Subject: 124 – 126 Bull Street, Newcastle West (MA2024/00381)

I am writing regarding modification application MA2024/00381 at 124-136 Bull Street, Newcastle West and the meeting held between the applicant and the City of Newcastle (CN) and the chair of the Newcastle Urban Design Review Panel held on the 9 May 2025. During the meeting it was discussed that anomalies were discovered in relation to solar compliance of the proposed development. The following information is provided in response to the matters discussed within the meeting.

Figure 1 Proposed design adjustments to the AC plant to improve sunlight access to the balcony and habitable rooms.

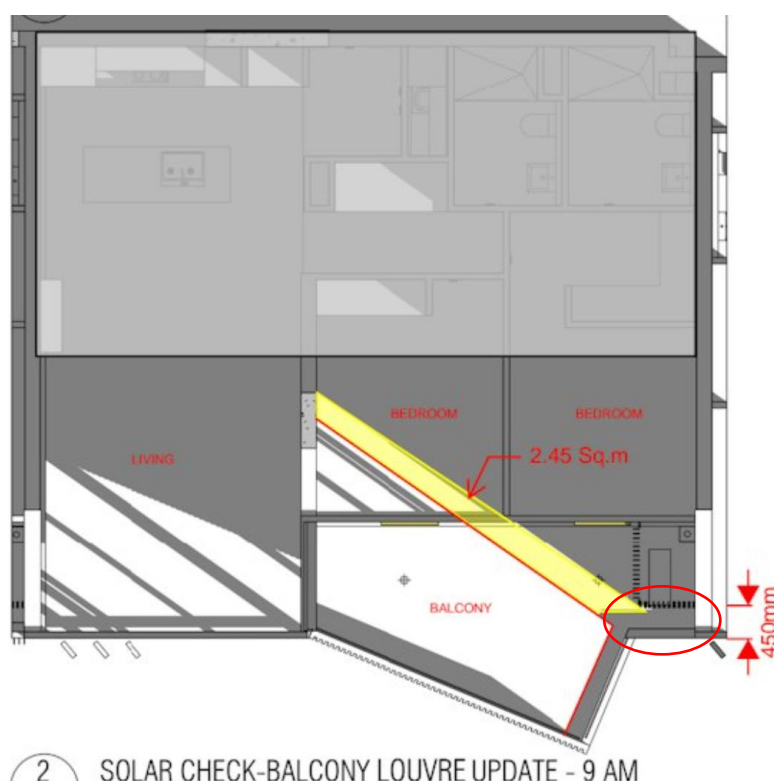
- Adjusting the design of the balcony AC plant enclosures as illustrated in Figure 1 below to increase sunlight access to the balcony and adjacent habitable rooms (bedrooms). It is noted that this design feature was suggested by the chair of the UDRP at the 9 May 2025 meeting to improve the solar access to the bedrooms and living room. Half hourly solar analysis of the proposed design adjustments has been included within Attachment 1.
